MONTGOMERY COUNTY HISTORIC PRESERVATION COMMISSION
STAFF REPORT

Address:	111 Elm Ave., Takoma Park	Meeting Date:	8/15/18
Resource:	Contributing Resource Takoma Park Historic District	Report Date:	8/8/18
Review:	HAWP	Public Notice:	8/1/18
Case Number:	37/03-18FFF	Tax Credit:	None
Applicant:	Sarah Boehm & Leonard Newmark	Staff:	Dan Bruechert
Proposal:	Window and Door alterations, and rear porch alterations

Figure 1: April 2012 view of the house showing the right rear windows.

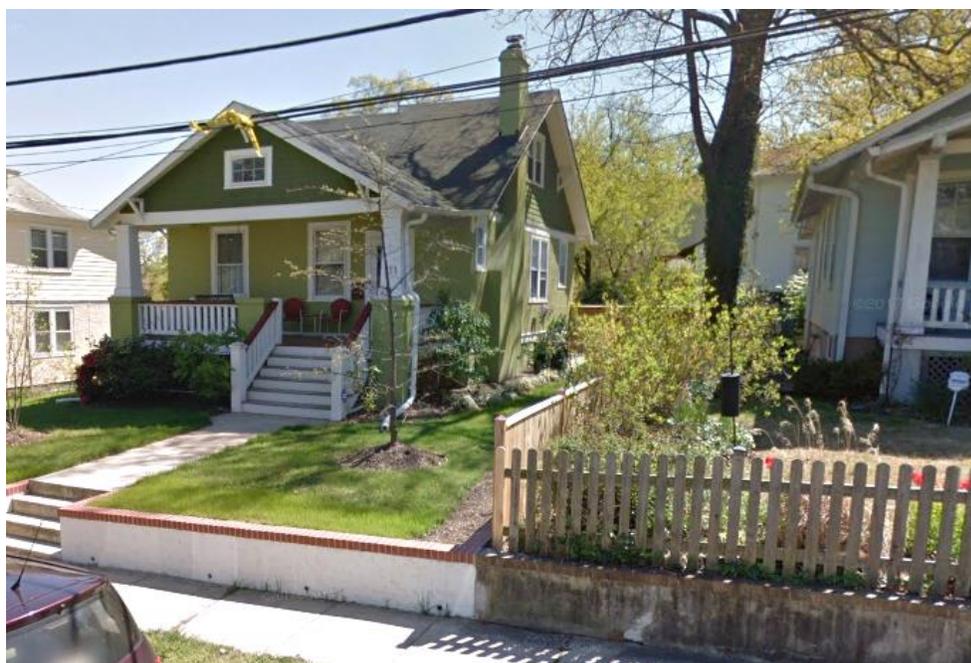
The applicant proposes to remove a window on the right elevation of the house and install a new clad window on the right side in a new window opening closer to the rear wall. The window proposed for removal on the right side is the rear-most six-over-one wood window. Information presented by the applicant at the preliminary consultation suggests that the wood windows throughout the house are historic. The applicant proposes install a new clad window in a new window opening 2' 6" (two feet, six inches) to the rear of the house.

The proposal evaluated at the Preliminary Consultation called for the removal of the paired sash window and the rear window on the west elevation and to install two smaller sash windows on the elevation in new locations. The proposal aimed to align new window openings with the reconfigured kitchen. Staff found that the proposal was contrary to the *Design Guidelines* which state, “Original size and shape of window and door openings should be maintained, where feasible.” Staff found, and the HPC concurred, that the historic paired sash windows were significant to historic character of the building and surrounding streetscape. Staff also determined that while the landscape around the house has matured, the windows on this elevation are visible from the public right-of-way when considered irrespective of the landscaping (see the c.2012 image below, prior to the maturing of much of the surrounding landscape).

The revised proposal calls for moving the rear window on the right (west) elevation by 2' 6" (two feet, six inches) and installing a new clad window in its place. The applicant will patch the existing opening and paint the wall to match. The applicant proposes to install a JeldWen Sitaline six-over-one wood clad window in the same size as the existing window with permanently applied interior and exterior muntins. At the preliminary consultation the applicant indicated that the sash cords were broken, and the build-up of paint made the windows difficult to operate. Staff does not believe that this alone is sufficient to justify the removal of a historic wood window and that if this historic window was repairable it could provide decades of continued use (there are also Montgomery County Tax Incentives available for the repair of this element). While the proposed replacement window will be the same size as the existing, Staff remains finds that the proposal does not comply with the *Design Guidelines*, which states that consideration should be given to maintaining original window and door openings, where

feasible. The proposed work is on a secondary elevation; however, the *Guidelines* do not dictate a less rigid adherence except when work will not be at all visible from the public right-of-way. Staff finds that approval of this HAWP should be conditioned on retaining the window on the west elevation to comply with the *Design Guidelines*.

1. The window on the west elevation, needs to be maintained its historic location;
2. The new rear window needs to be wood. A clad window in this location is not appropriate. Submitted permit drawings must reflect compliance with this condition; and
3. Detailed specification for the skylights must be submitted for review and approval to Staff with the permit drawings with final approval authority delegated to Staff;

② REAR ELEVATION - PROPOSED
1/8" = 1'-0"

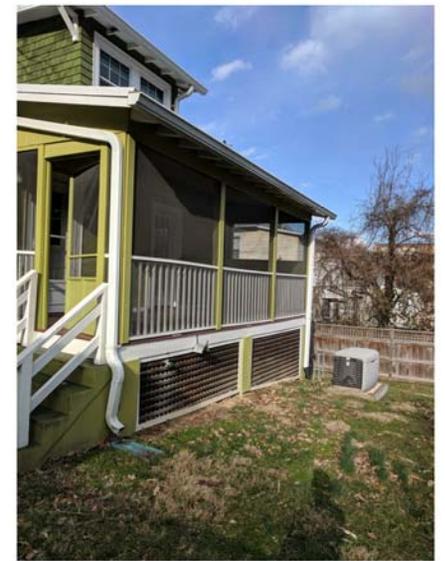
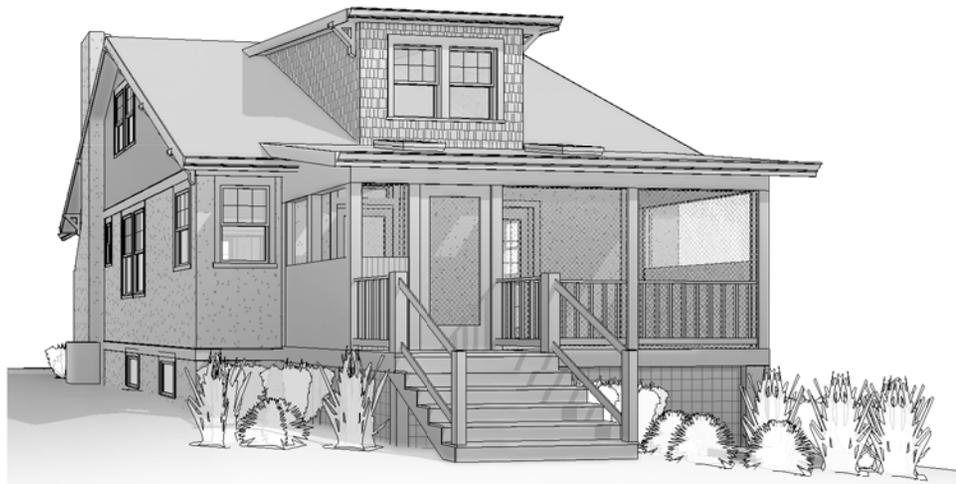
The applicant proposes to remove the existing side loading steps, fill in the existing screen door opening with a beadboard panel, install new rear loading wood steps matching the appearance and materials of the removed steps, install a new screen door, and to install two Velux skylights (cut sheet attached) in the porch roof.. The applicant also proposes to move the rear door several inches and reinstall it. Staff finds that these modifications do not detract from the character of the house or the surrounding district and Staff supports approval in accordance with 24A-8(b)(1). The *Design Guidelines* state that "minor alterations to areas that do not directly front on a public right-of-way such as... skylights should be allowed as a matter of course. While Staff finds that the proposed alteration is acceptable per the *Guidelines* permit drawings need include detailed specifications for the skylights. Additionally, these changes are not visible from the public right-of-way within the boundaries of the historic district and the *Guidelines* state that these changes should be approved as a matter of course.

The applicant proposes installing a window on the rear (south) elevation near the southwest corner of the house. The proposed window for the newly created opening will be a JeldWen Sitaline six-over-one wood clad window with permanently applied exterior and interior 7/8" (seven-eighths inch) with putty bevel-profiled muntins (see pages 26 for details). The proposed window will be the same size as the historic sash window discussed above in the same lite pattern, making the design appropriate for the architectural style of the house. This window will be partially visible from the public right-of-way, but in a location that is outside of the historic district. Staff finds that even though this new opening is at the rear of the house, because it is being created within the house's historic building envelope, the window needs to be wood to be compatible with the historic materials. Staff recommends conditioning approval of this HAWP on the use of a wood window being installed in the proposed opening. The new window should match the dimensions and profiles of the proposed clad window. The applicants identified window manufacture, JeldWen, makes a wood window in matching dimensions. Staff recommends that permit drawings showing a wood window installed in the rear elevation must be submitted for review and approval with final approval authority delegated to Staff.
